Special Town Council Meeting

- A. Sketch Plan for a +/-190,000 sf (habitable) Mixed-Use Hotel and Condominium Development within Five Buildings Along North Cache (P24-170) (Tyler Valentine)

STAFF REPORT

LEVEL 1
PLAN

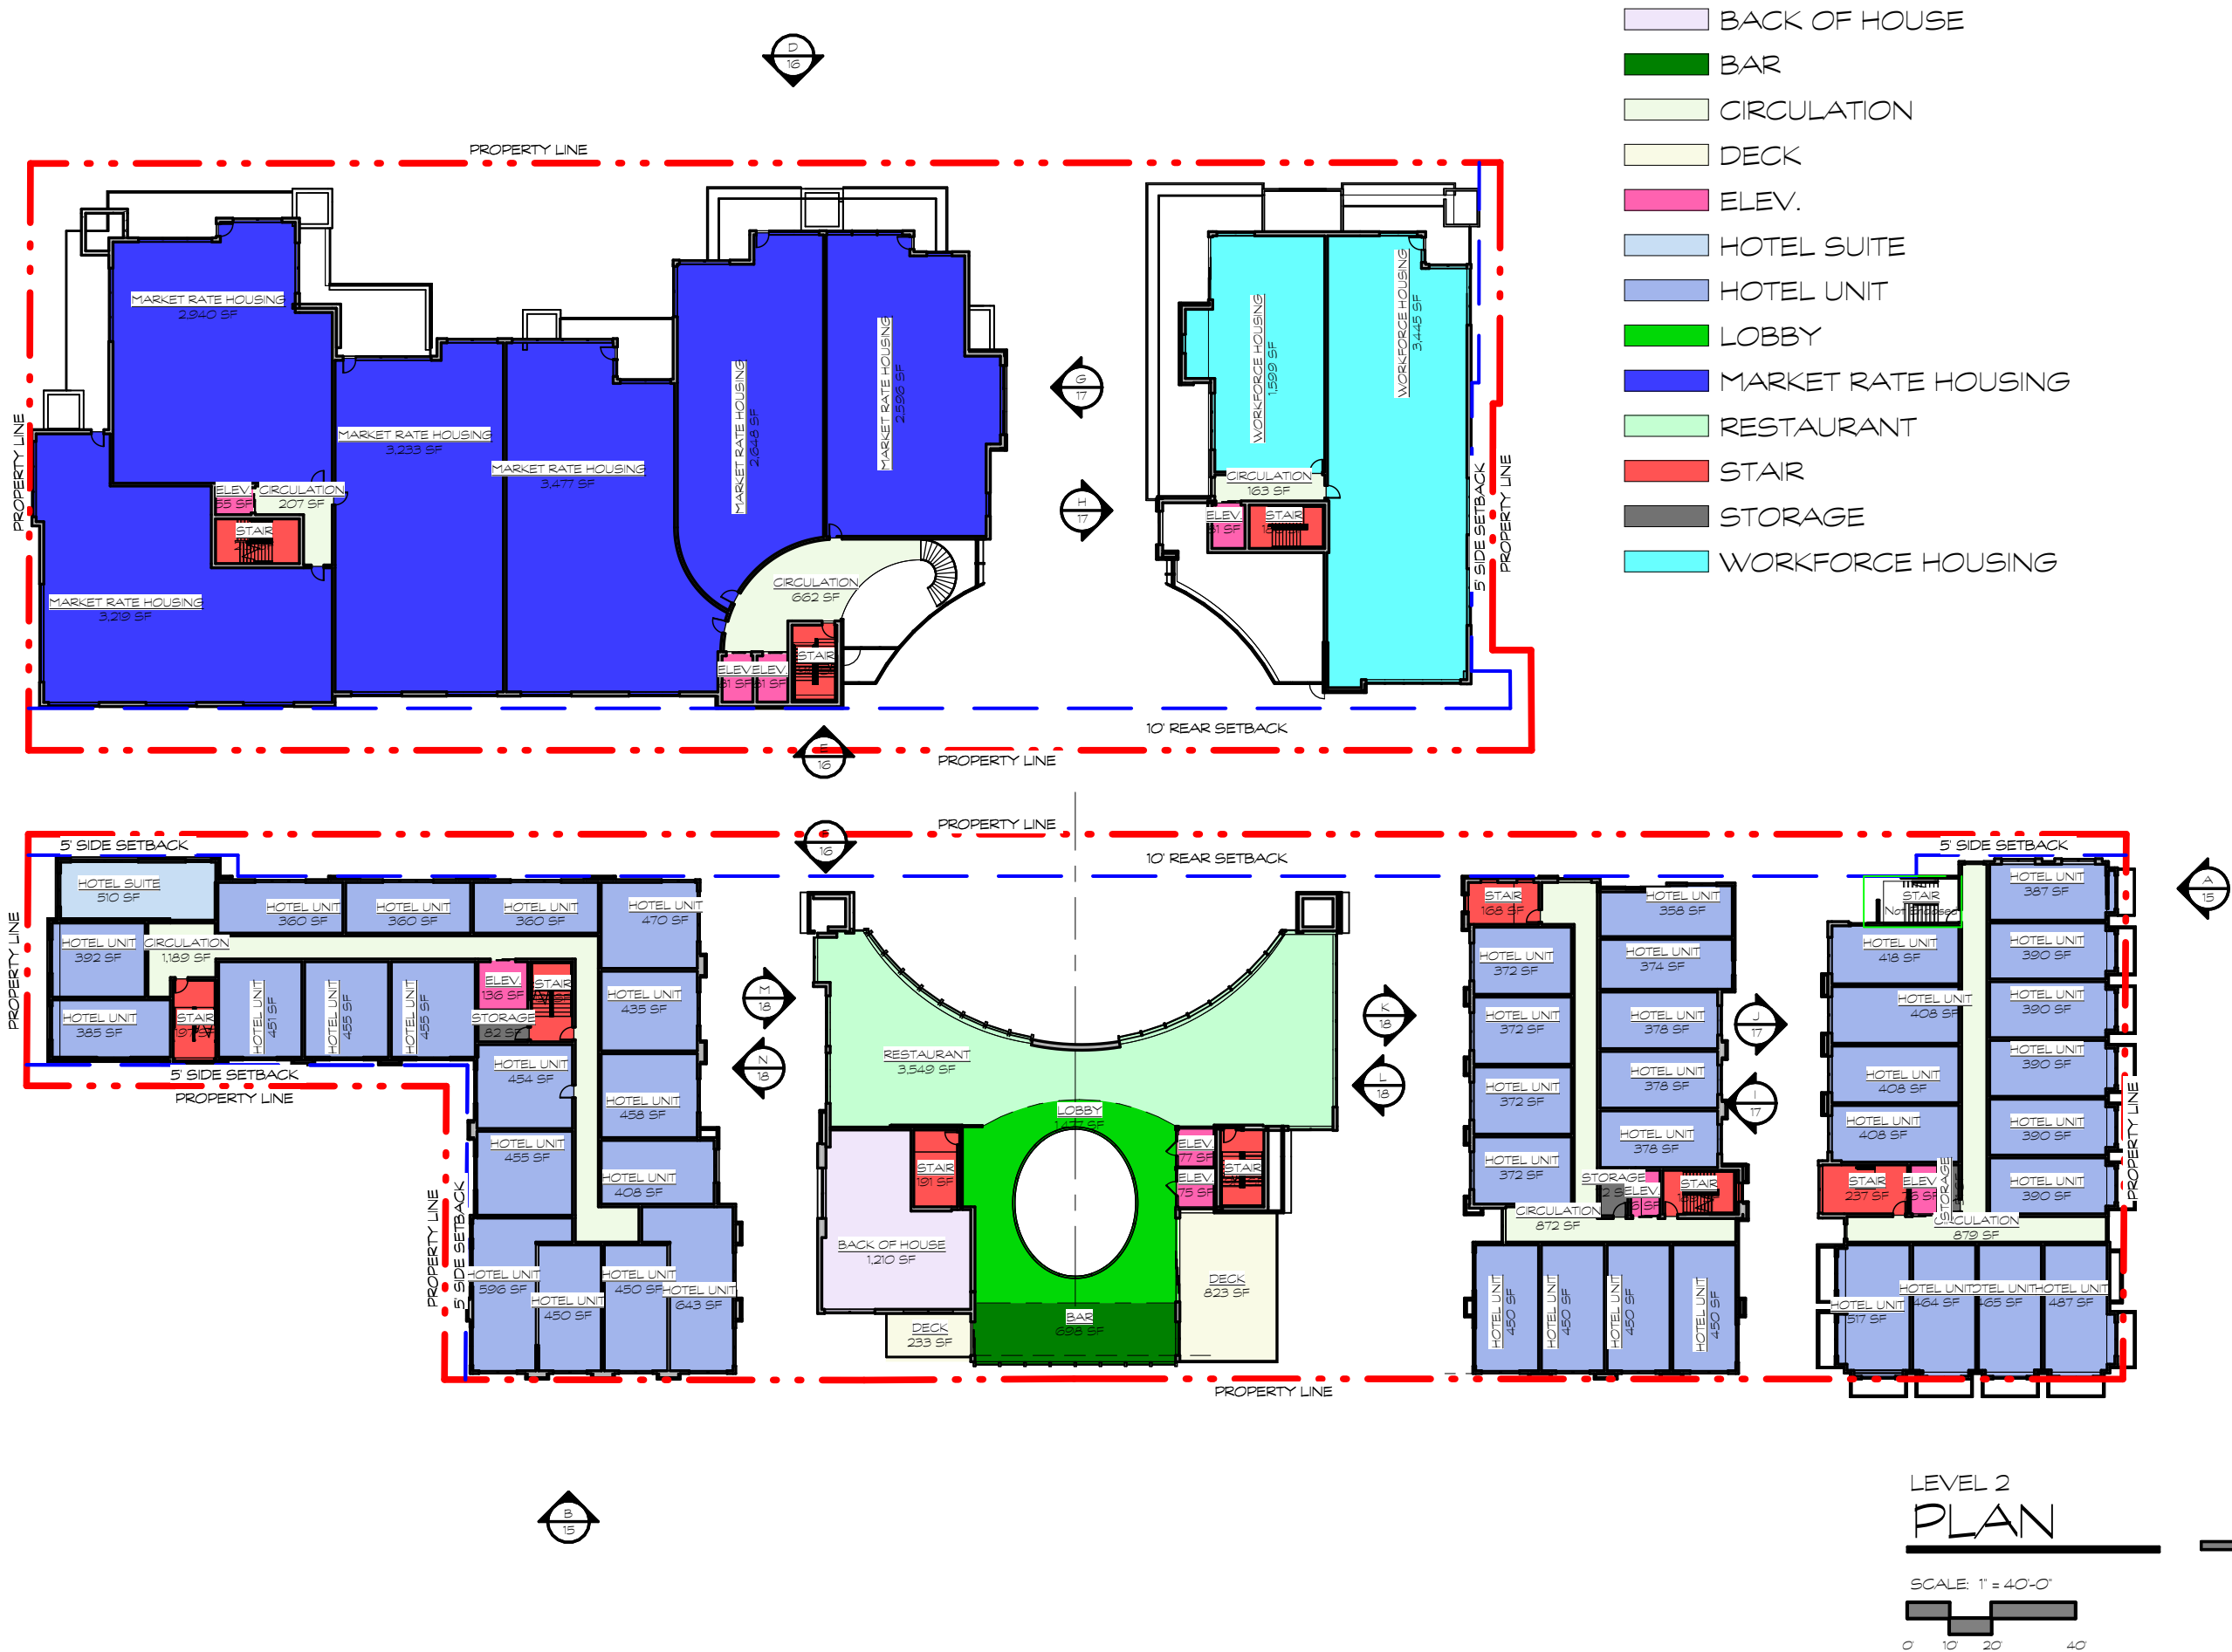
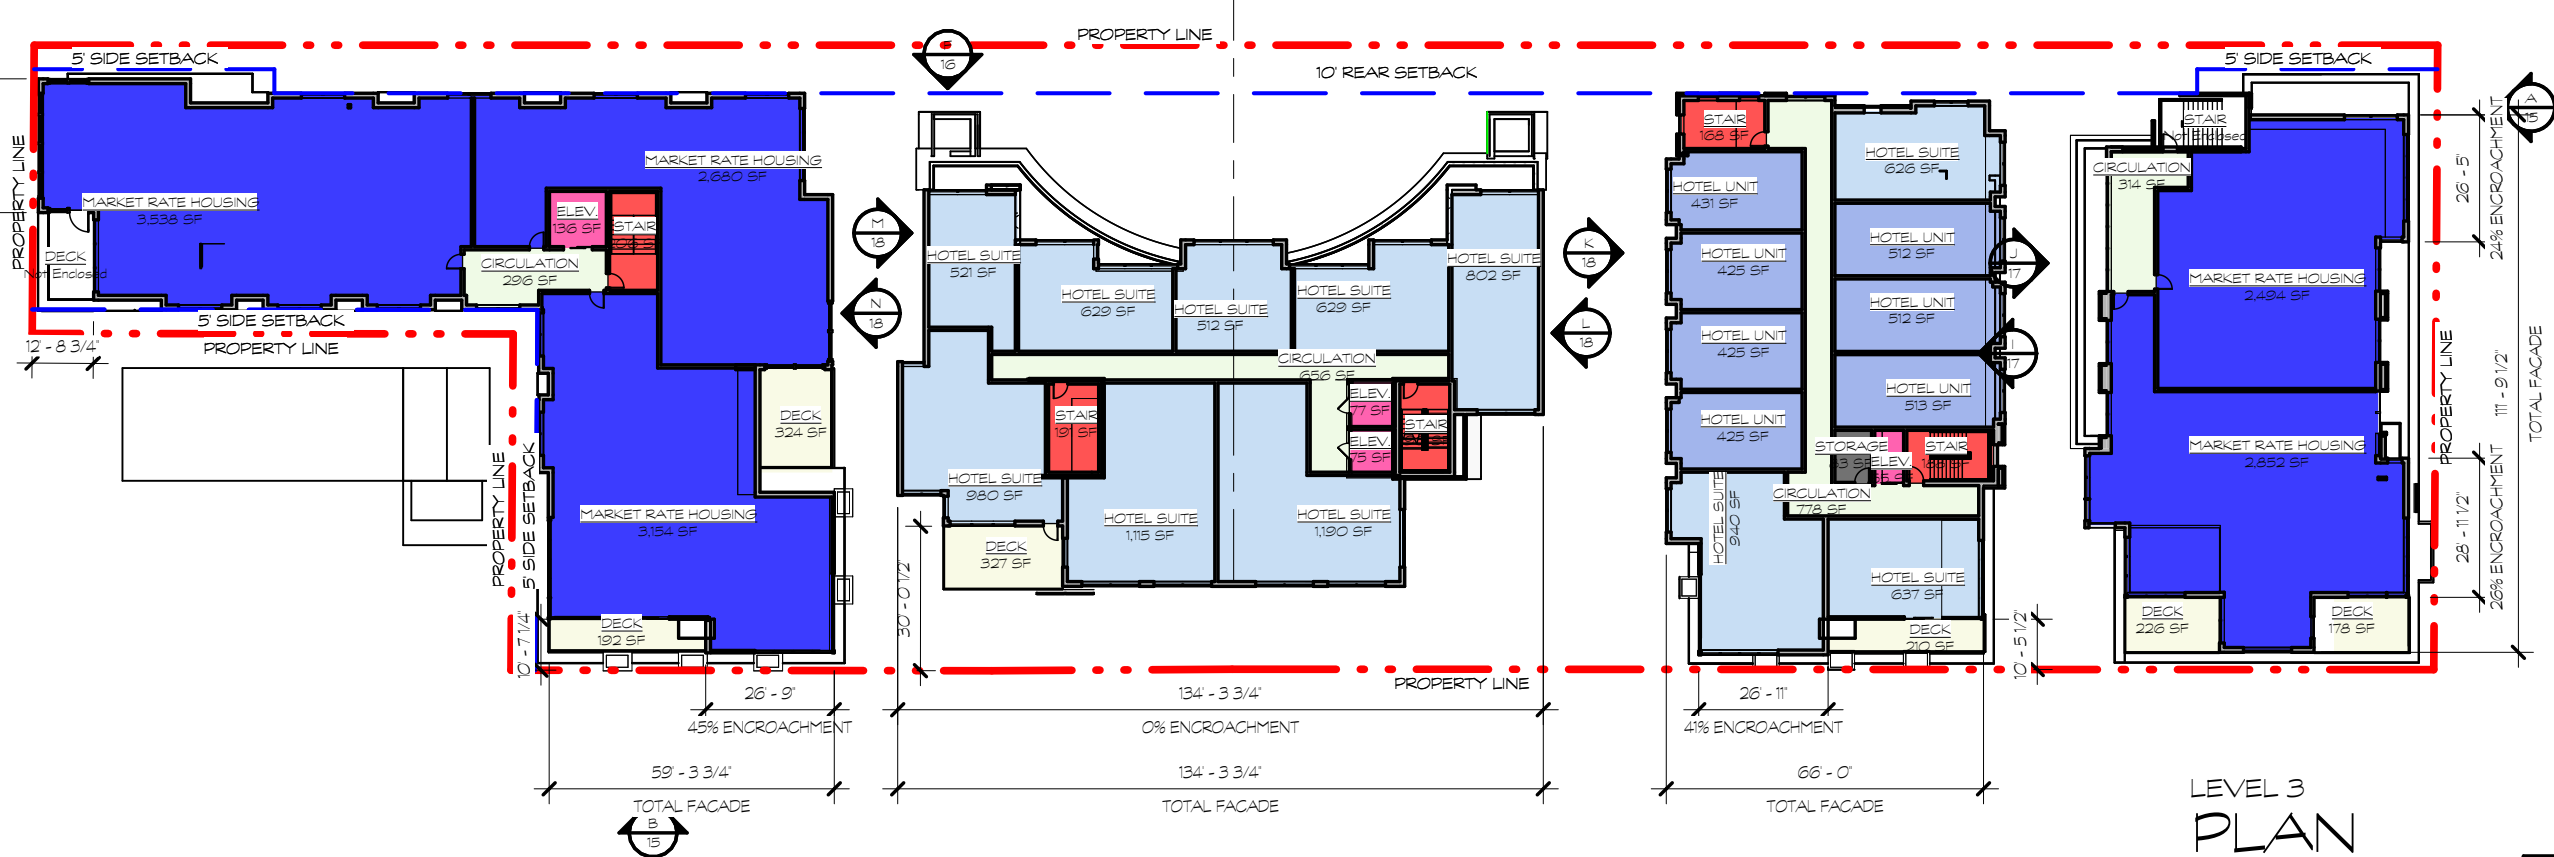
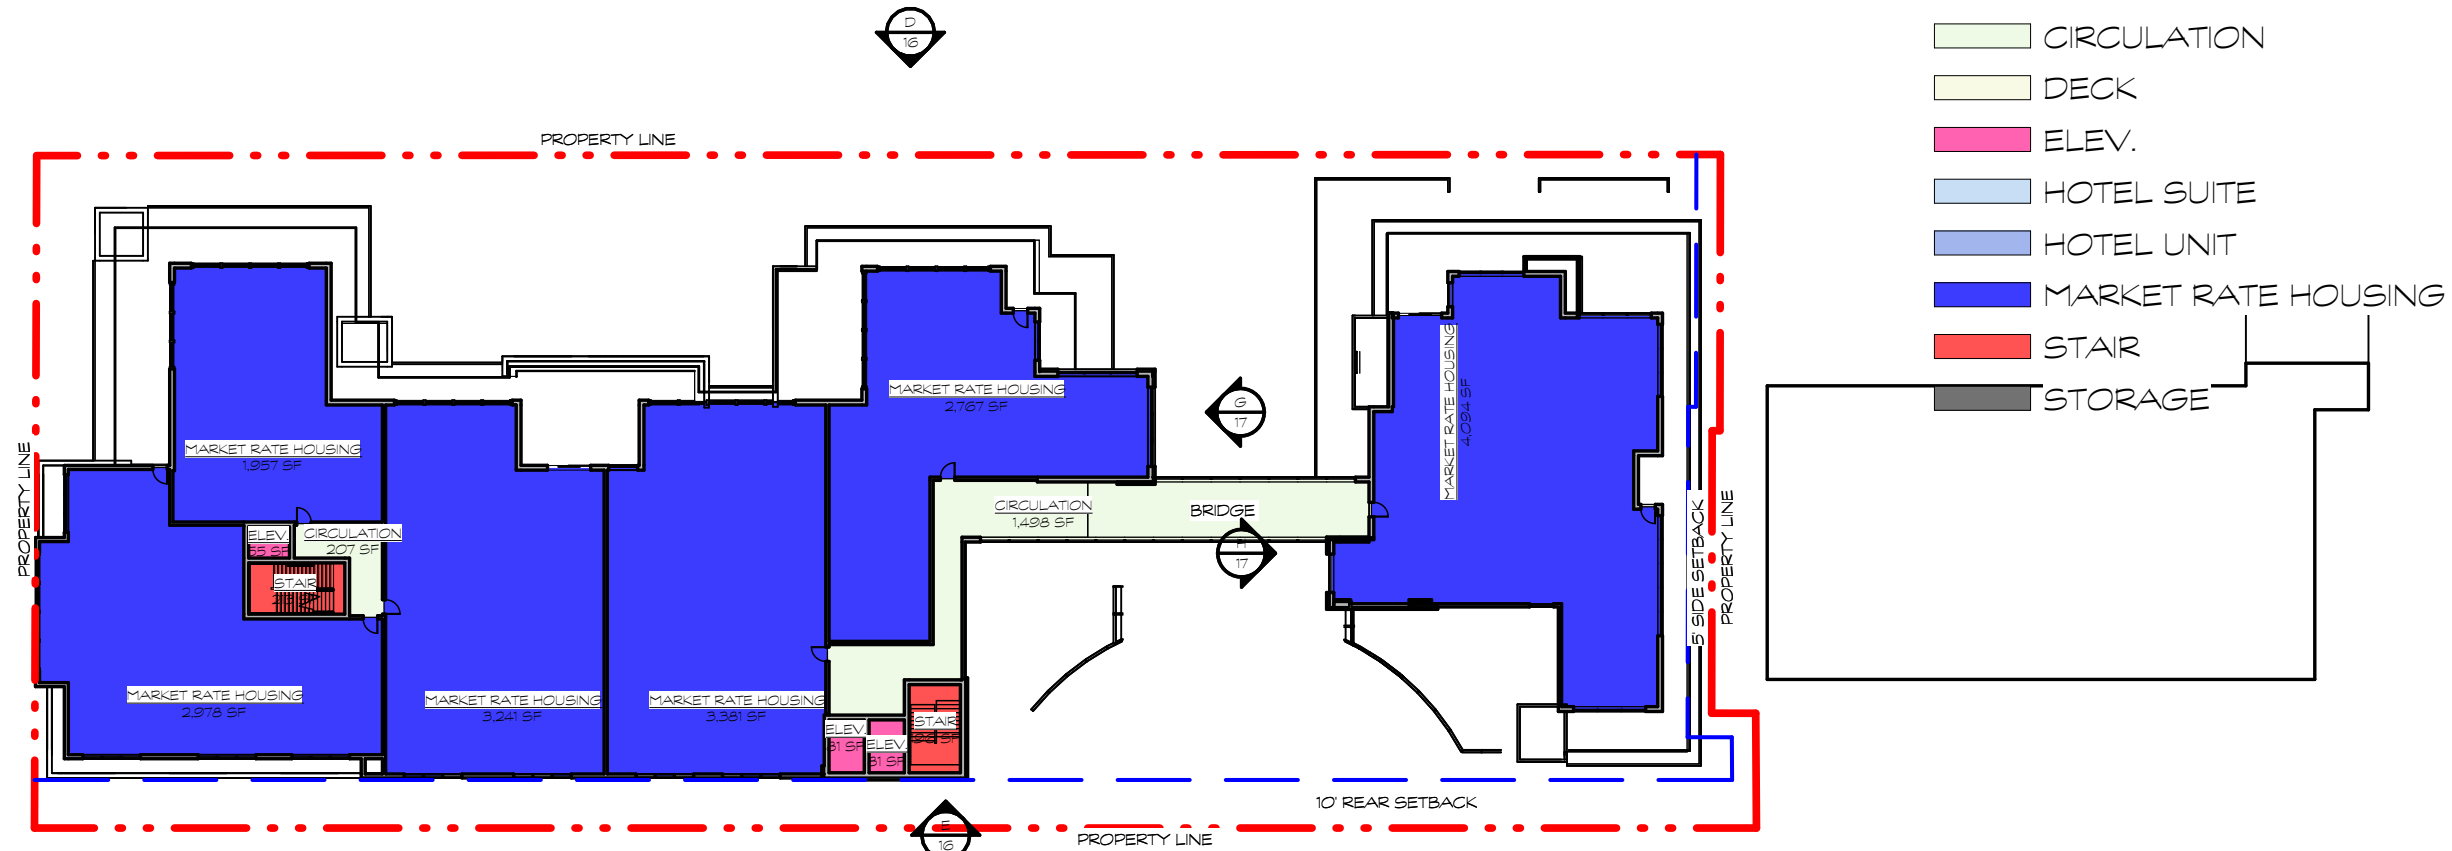
- *All proposed floor area must be accounted for in the housing mitigation calculator.* The Program Data on Sheet 4 of the proposed plan set lists a total proposed building area of over 244,000sf square feet but the Housing Mitigation Calculator sheet 1 only accounts for hotel rooms and restaurant/bar space. In Development Plan submittal, the applicant should account for all proposed square footage. "Circulation or Nonhabitable Space" may be selected for areas like hallways, stairs, and parking.
